Applicant : Handique, *et al.*
Serial No. : 10/567,002
Filed : January 31, 2006
Page : 23 of 34

AMENDMENTS TO THE DRAWINGS

Applicant's Amendment and Reply to Office Action dated January 30, 2008
Annotated Sheet Showing Changes

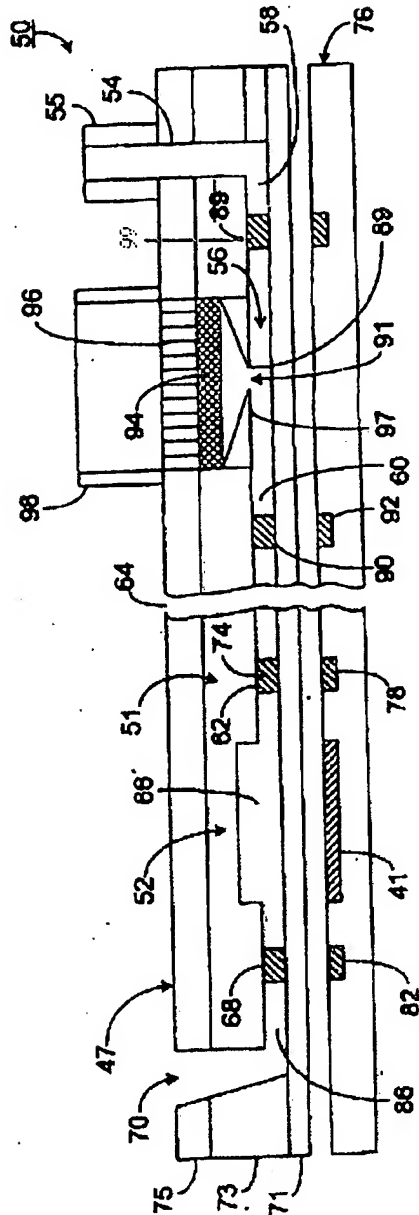
FIG. 2 has been amended to correct the reference numeral 89 to 85. The positioning of such new or revised reference numerals is based on other drawings as filed and the accompanying description found in the specification as filed.

FIG. 6A

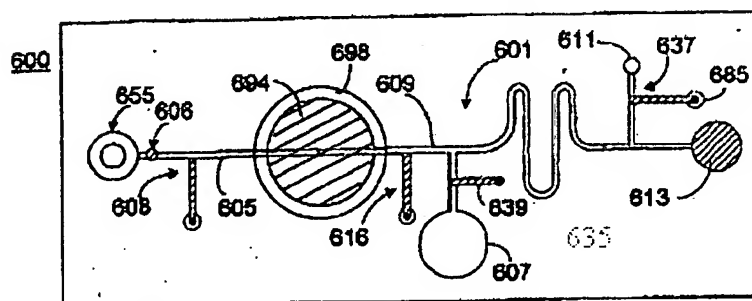
FIGs. 6a, 6b and 6c have been amended to replace the reference numerals 698, 697, and 697 by, respectively, 699, 696, and 696. The positioning of such new or revised reference numerals is based on other drawings as filed and the accompanying description found in the specification as filed.

FIG. 9A

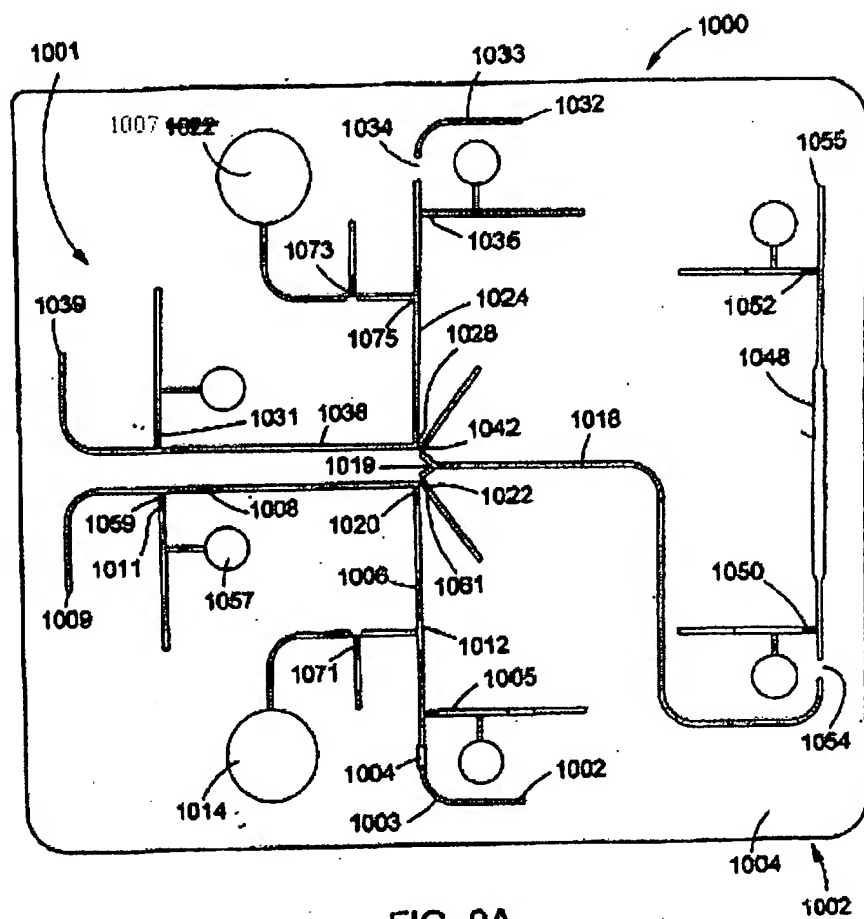
FIG. 9a has been amended to correct the reference numeral 1022 to 1007. The positioning of such new or revised reference numerals is based on other drawings as filed and the accompanying description found in the specification as filed.
